## CSP 25-056 AL BP041 – ADDENDUM No.01 HVAC MEP EAST ZONE 3

Fort Bend Independent School District  
2023 Bond Program

Addendum 01

13 August 2025

SO-M4.00

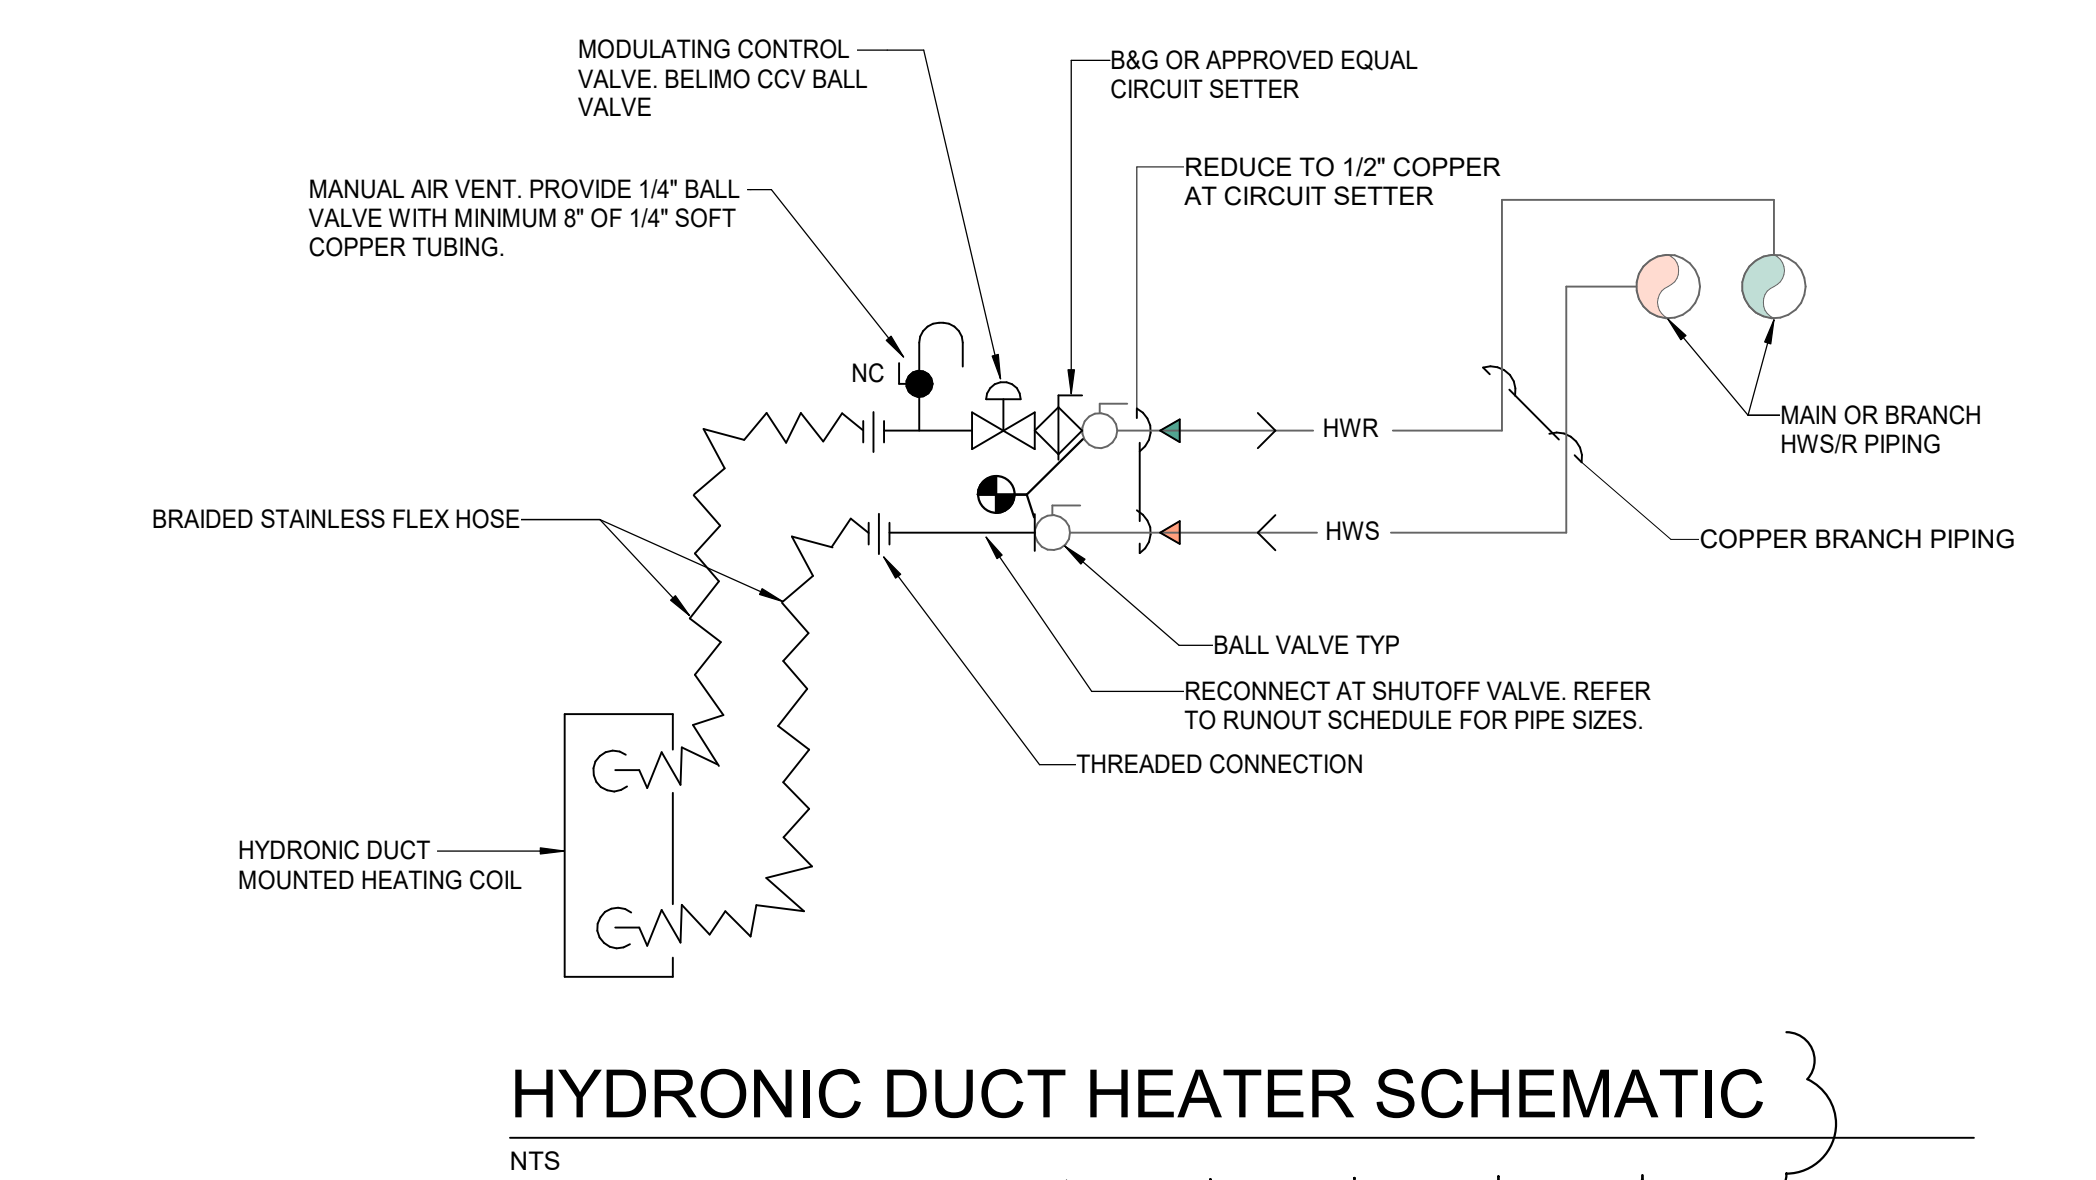
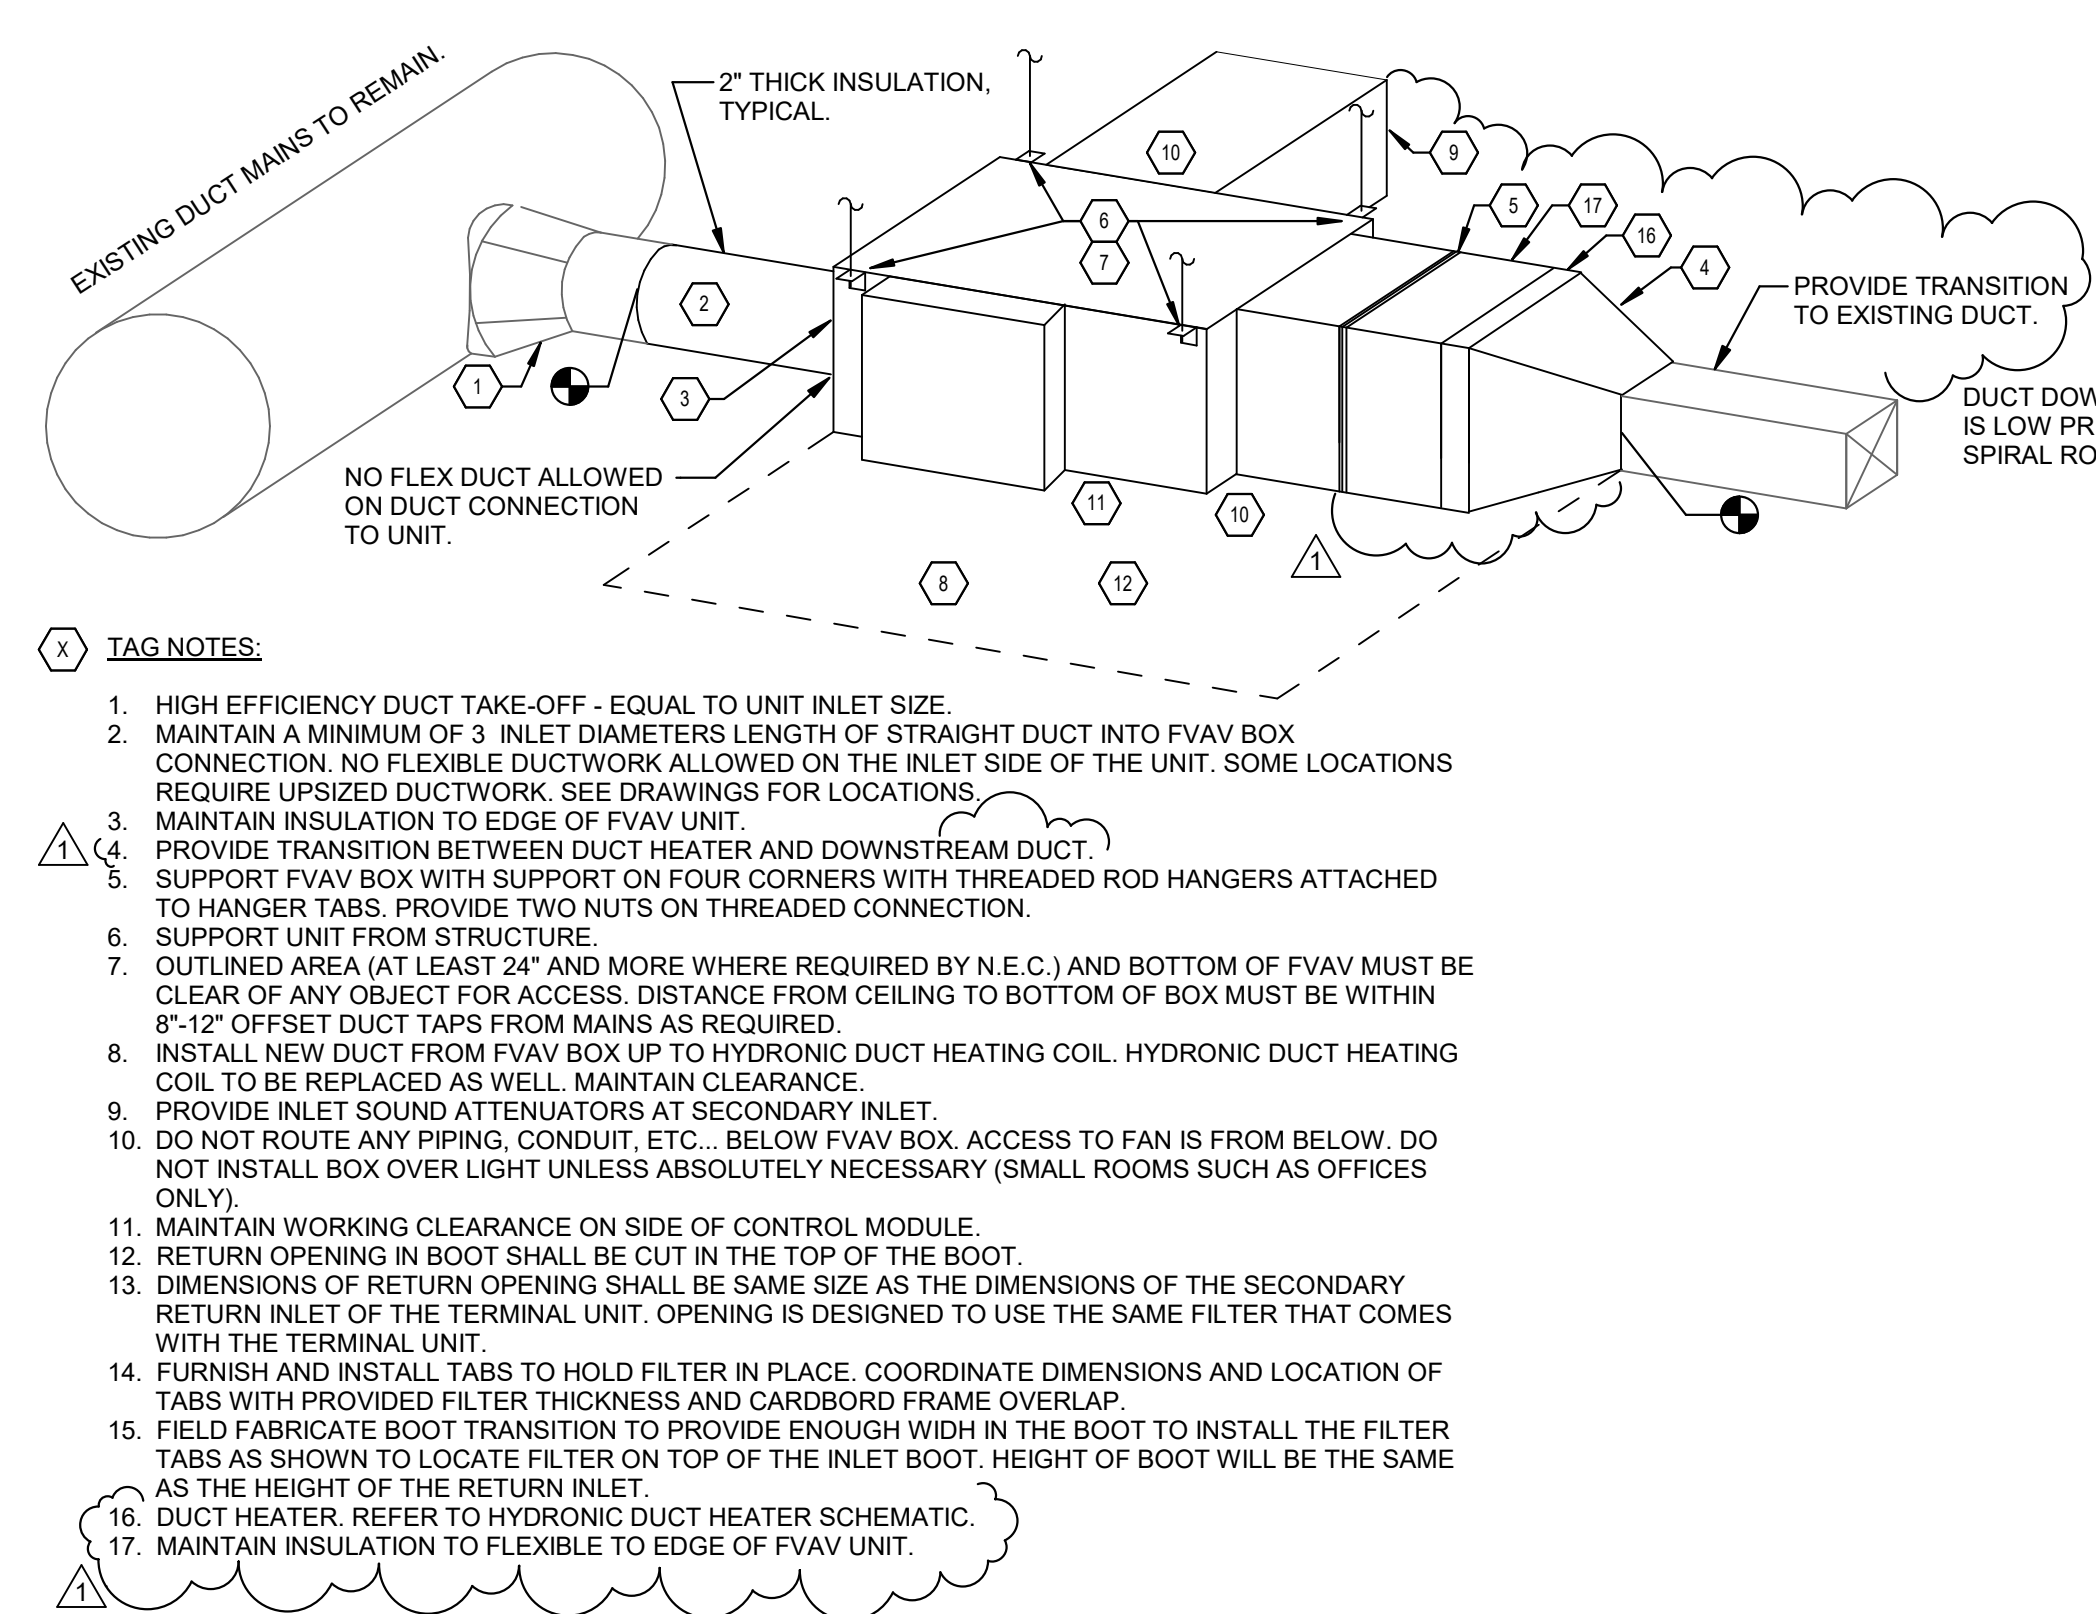
**12 Sheet SO-M4.00 – MECHANICAL DETAILS**

- a. Renamed Hydronic Duct Heater Schematic.
- b. Identified duct heater on Terminal Unit Installation Detail.
- c. Changed duct transition to downstream of duct heater.
